Ref no: 000215

Concerning Part Name : 0603 Series as the following table,

Product Type : Chip Inductor

Classification of Change : Packing material

Packing Specification

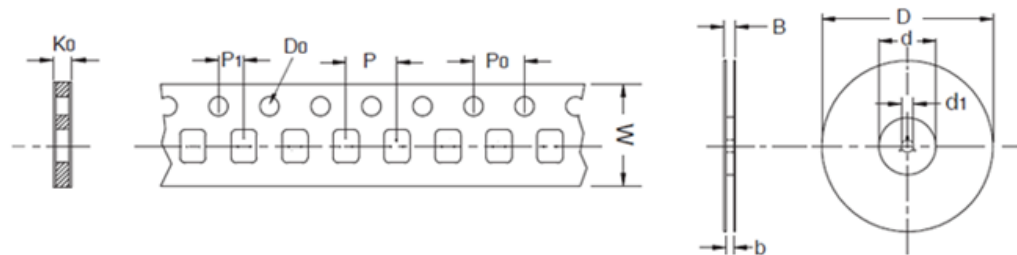
Description of Change : Change from embossed plastic to paper carrier tape. Details of paper tape dimensions see below in the table.

drawing only schematic, see table

Packing Specification in paper tape:

Type	Packing Code	D	Do	d	d1	B	b	W	P	P0	P1	Ko	T
0603	01,08	180	1.55	60	13	12.7	8.4	8	4	4	2	0.97	1.05
0603	04	330	1.55	100	13	14.4	8.4	8	4	4	2	0.97	1.05
